ORDER UNDER SECTION 96 (2) OF ACT, III OF 1901.

Re: Bungalows on plot No. 15 & 16, C.L.6, Civil
Lines Quarters.

PROPOSED BUNGALOW
ON PLOT NO 15 & 16 SHEET NO C.L. 6
CIVIL LINES QUARTER
SCALE 8 FEET TO AN INCH

AMENDED PLAN FOR PROPOSED DUNGALOW ON PLOT NO 15 & 16 SHEET NO C.L.6

Amended plan for plots nos. 15 & 16. C.L. 6 Civil lines

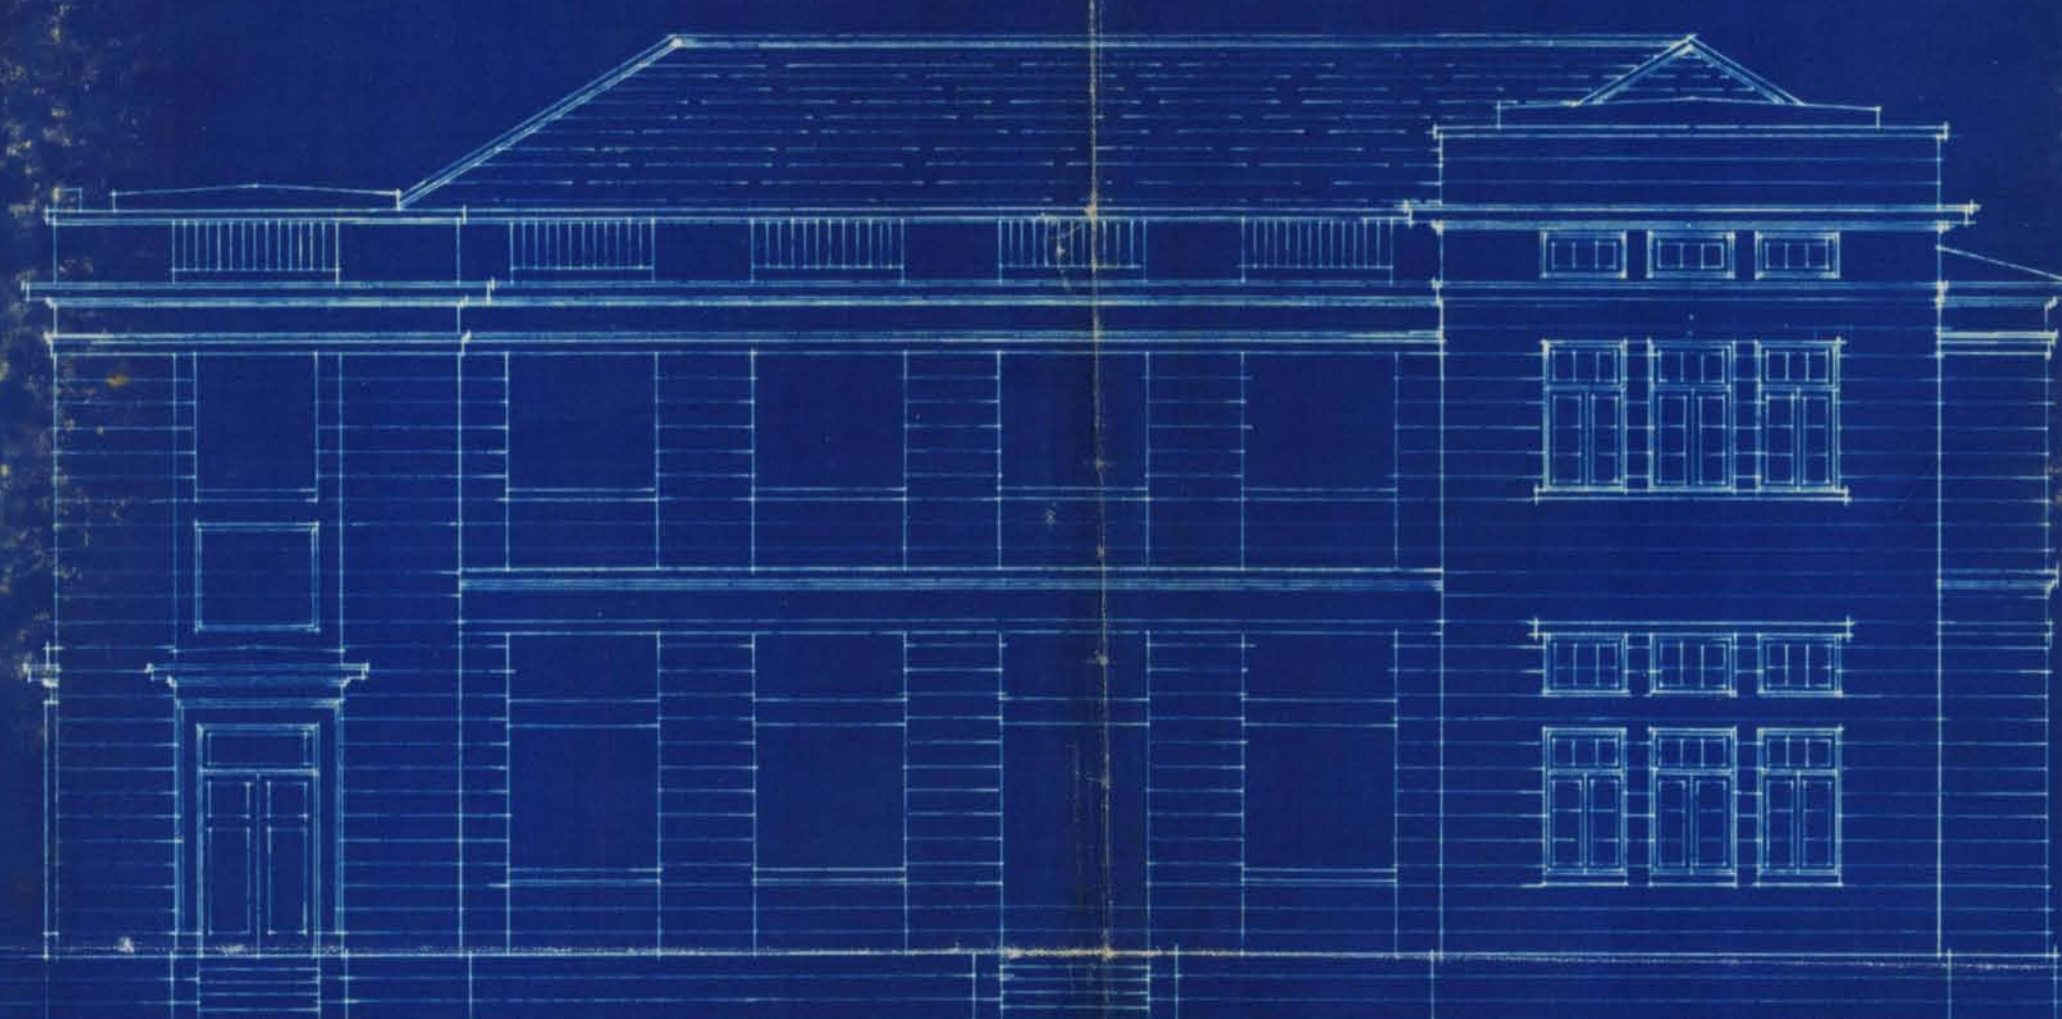
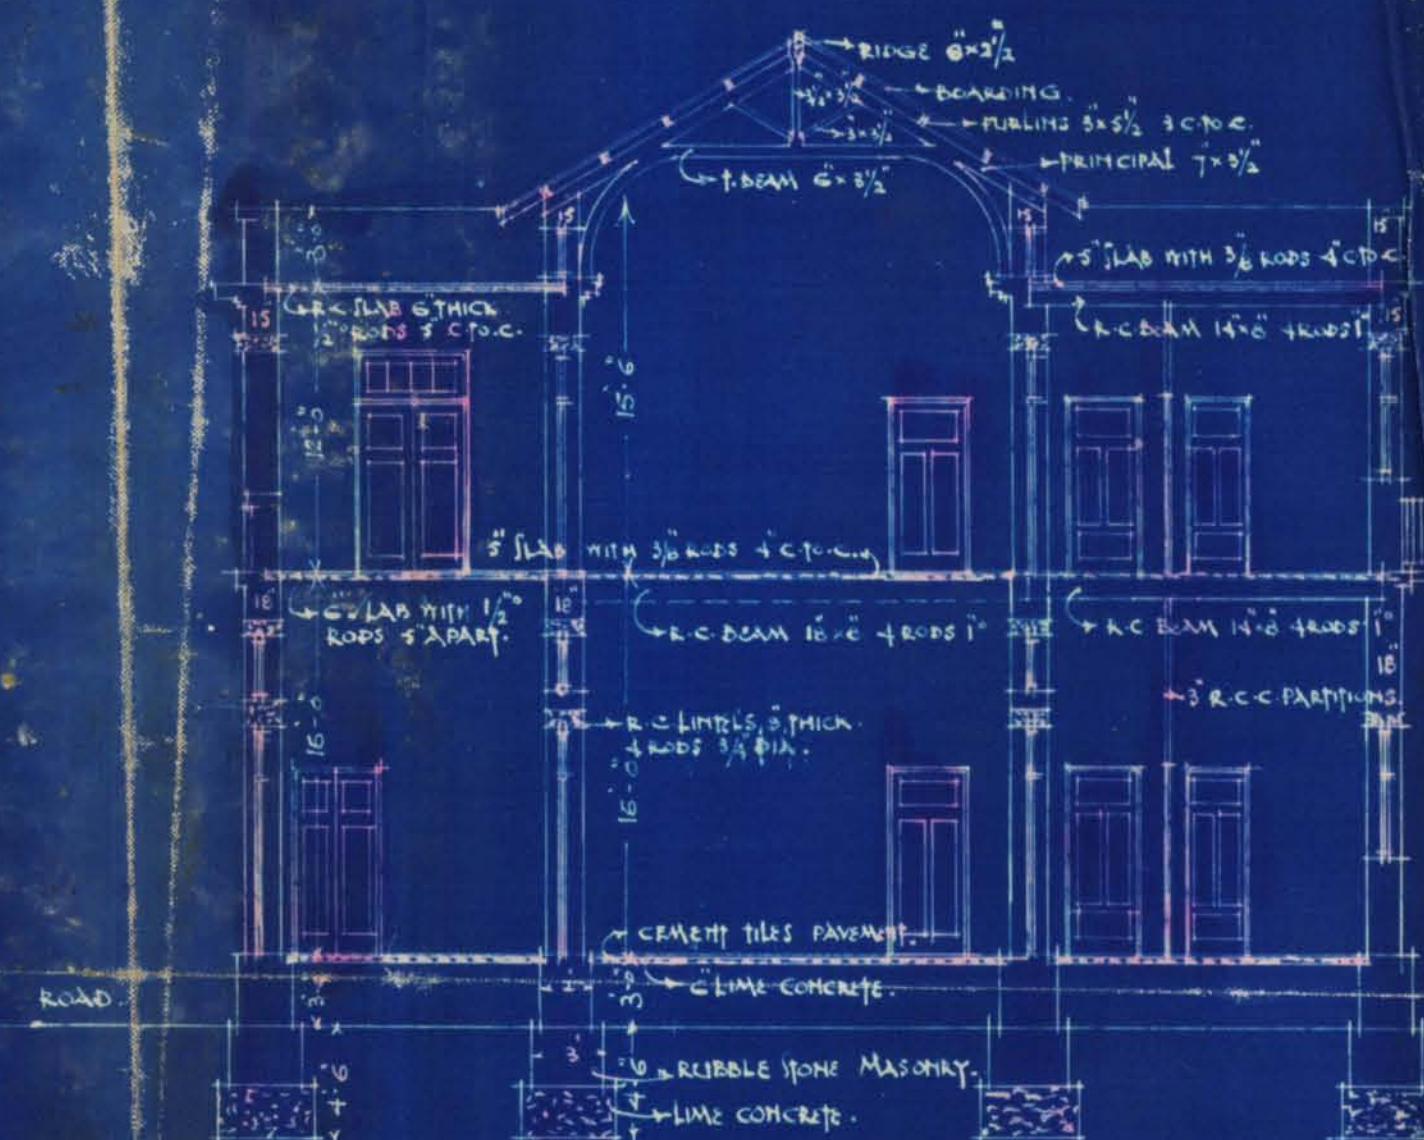
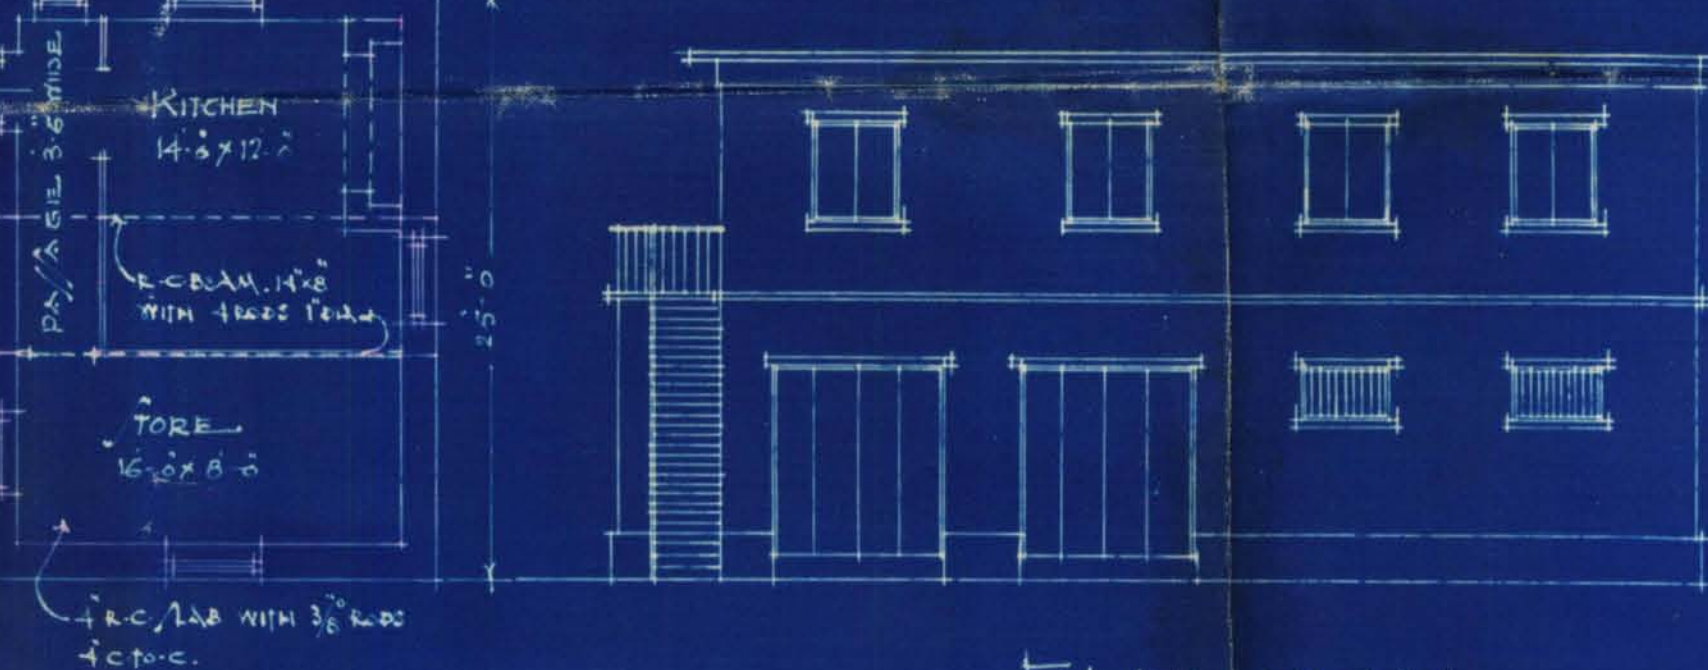
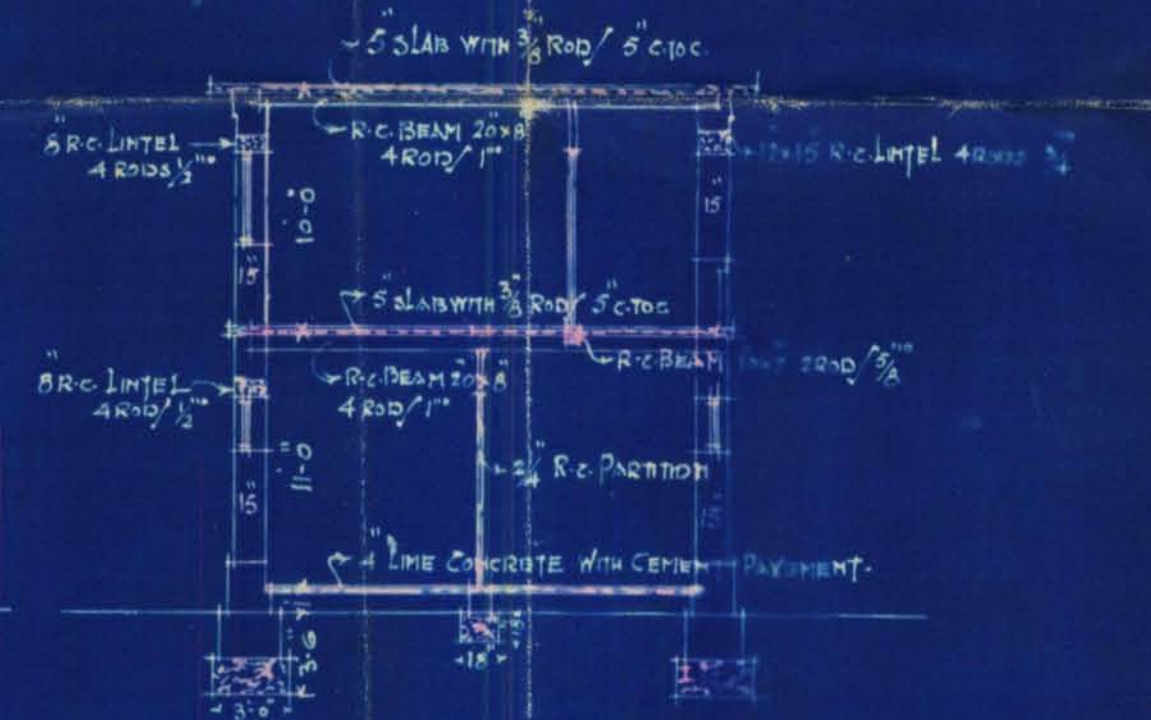
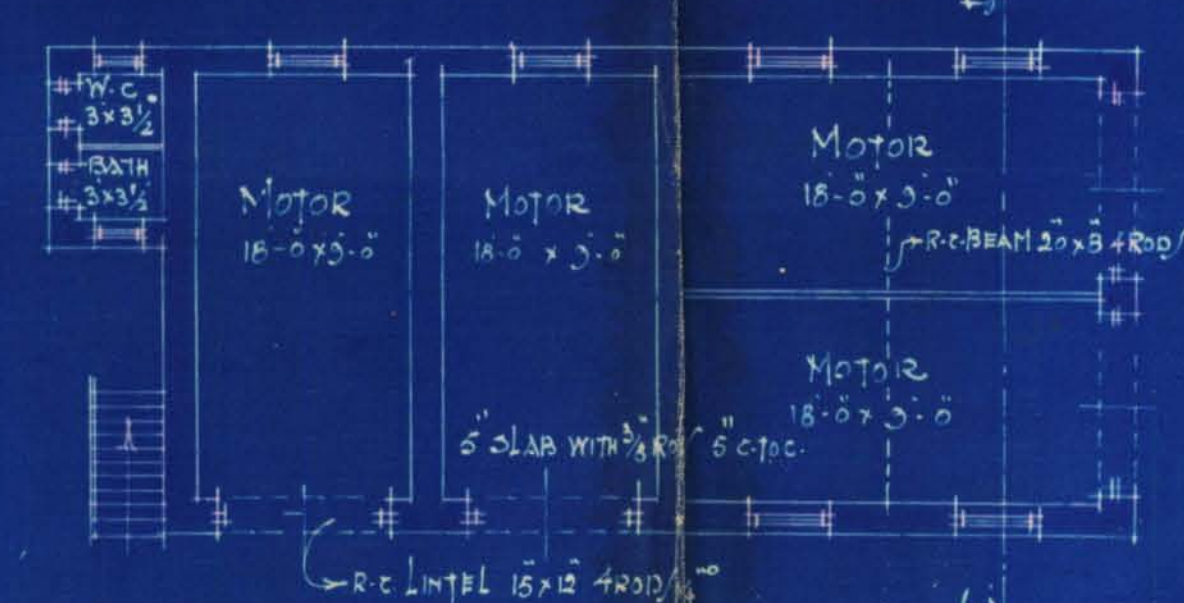
There is no objection as these plans are similar to those
passed first. The plans may be passed as the H.O. has no objection
also.

Plans may be approved
